SOFTWARE RELEASE NOTES

MCS-CONFIG

Version 8.00I

03/04/2011

Typical Sensor Wiring:

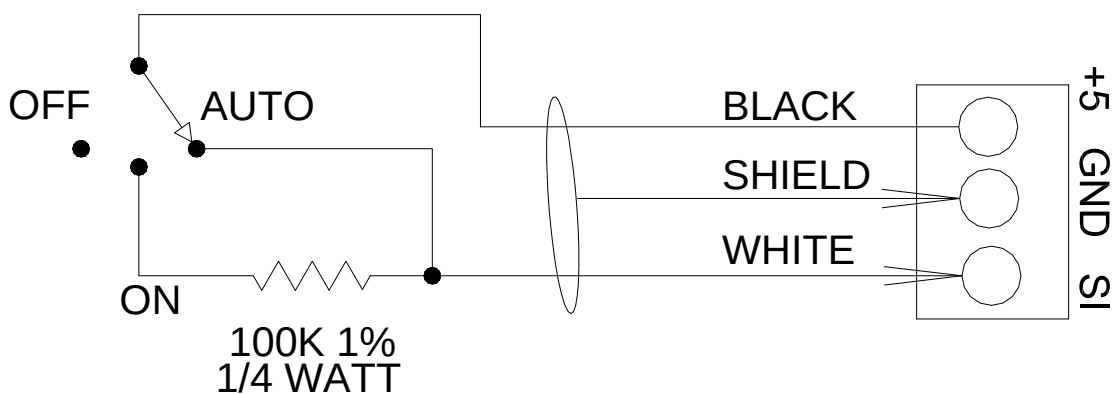
1. A 3 position Mode Select Switch (MODE SEL SW) sensor type has been added to CENT software configurations for use with Trane purge control logic.

Switch Position	Voltage at SI
OFF	0vdc
ON	2.5vdc
AUTO	5.0vdc

Conversion Logic in Magnum Software

If Sensor Input voltage is less than 1.5vdc, then the mode is OFF.

If Sensor Input voltage is less than 3.5vdc, then the mode is ON.

If Sensor Input voltage is between 3.5vdc and 5.0vdc, then the mode is AUTO.
